Our Ref: 35065-002-01
Your Ref: DA/4731

Information Request Response
Development Application for Reconfiguring a Lot (1 lot into 2 lots)
47 Buhmann Street Cooktown – Lot 2 on SP319394

ATTACHMENT A

Photo 1

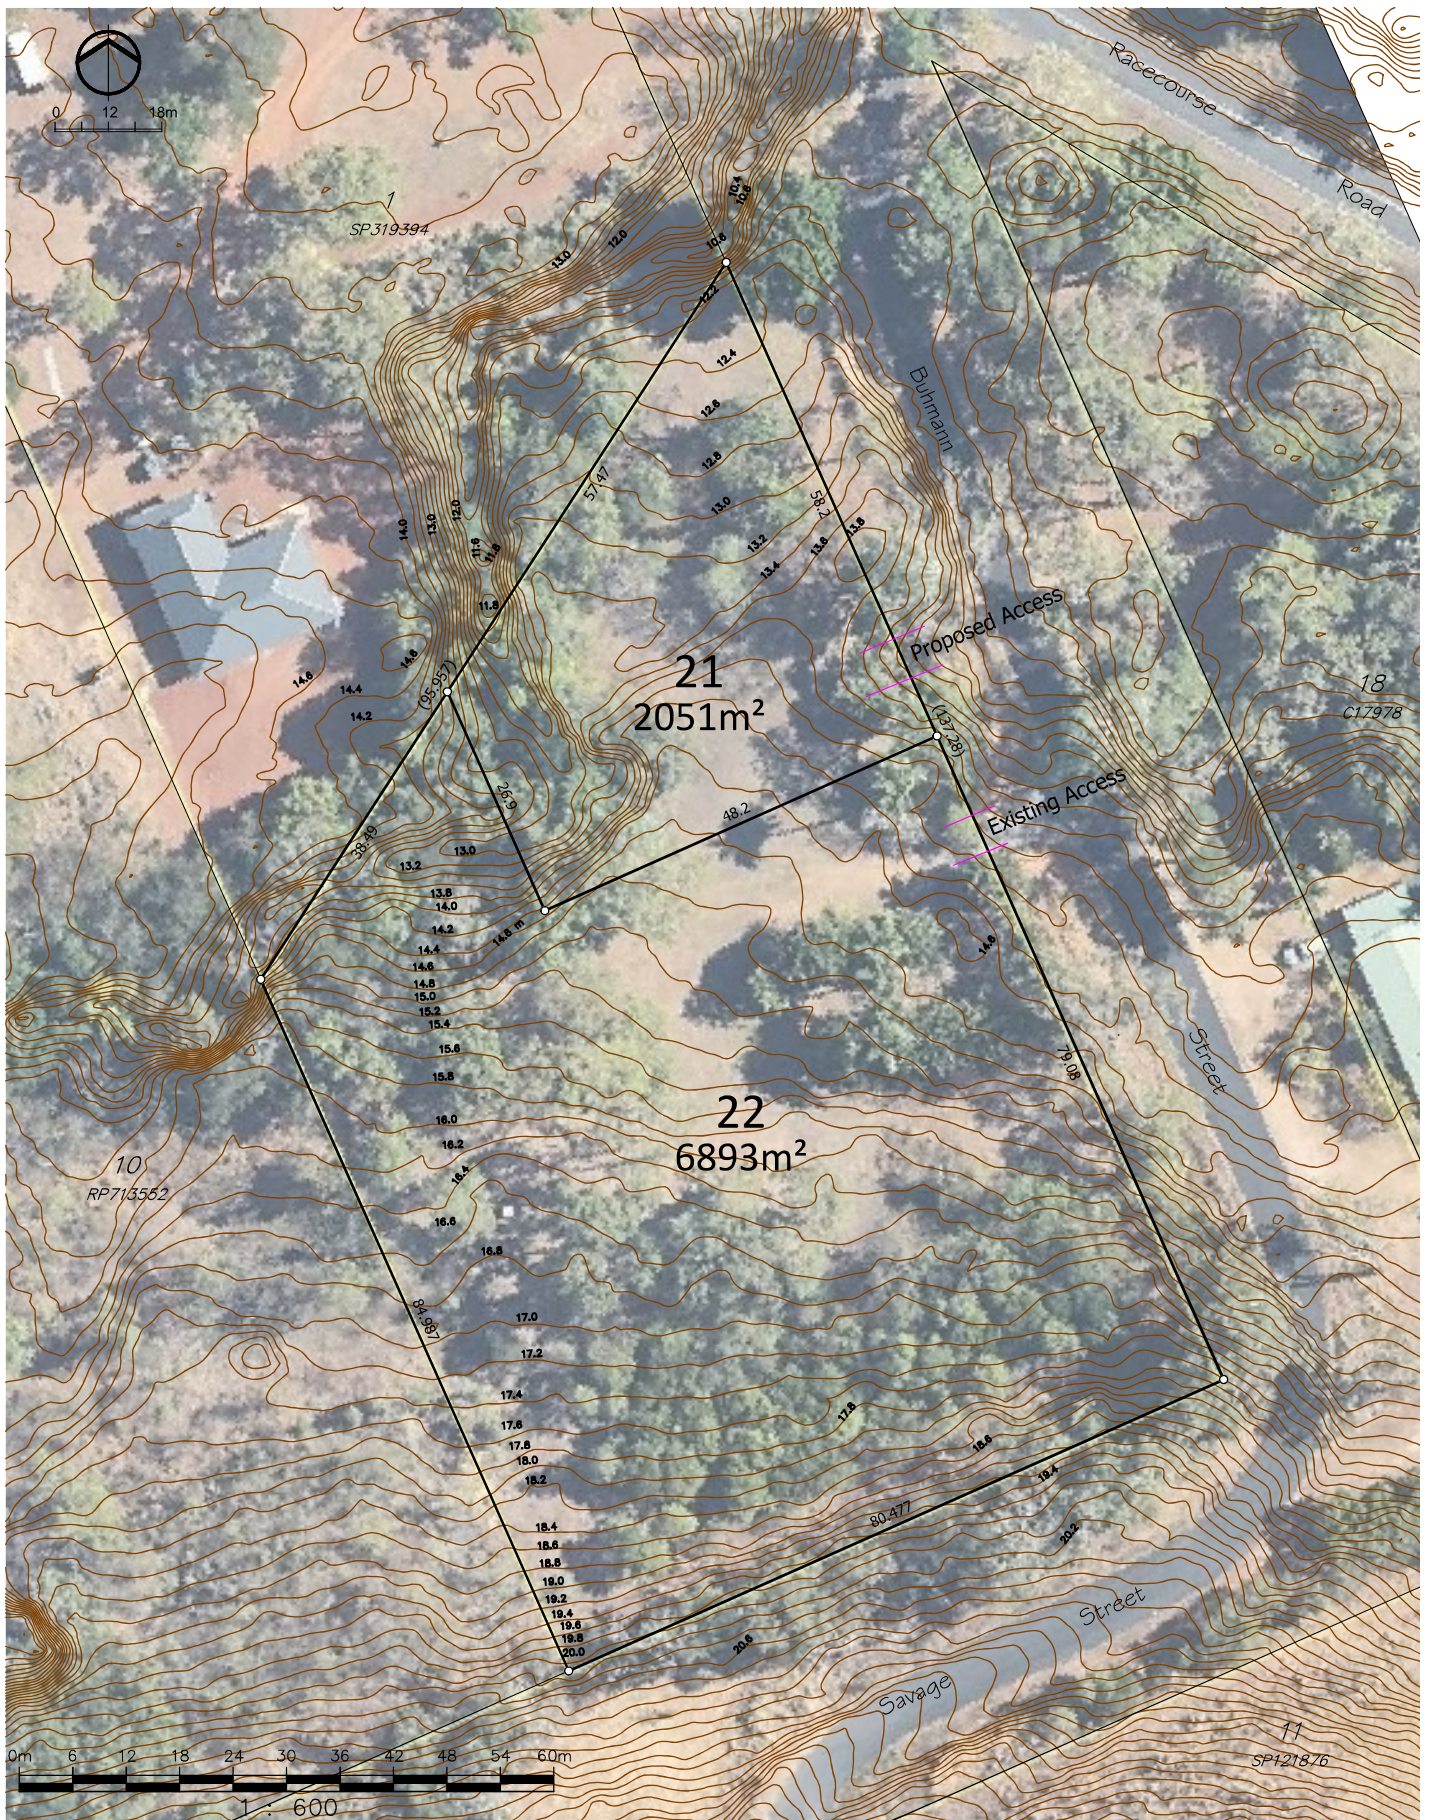
2. *The Applicant is requested to demonstrate that the risk of flooding to proposed Lot 21 is low, or that the risk can be reasonably mitigated by minor filling of the building pad to achieve 300mm freeboard above the 1% AEP flood level.*

Advice note: A review of the existing drain at the rear of proposed Lot 21 appears to indicate that the 1% AEP flows are contained, however needs to be confirmed.

Photographic evidence provided by the applicants, included within *Attachment B*, taken during the flooding event of 17 December 2023 confirms that stormwater conveyed through the site, did not exceed the capacity of the drainage. The photographs were taken during the peak of the rainfall event. Upon the rain event easing the water level rapidly reduced back to the typical ankle-deep wet season runoff experienced within the site.
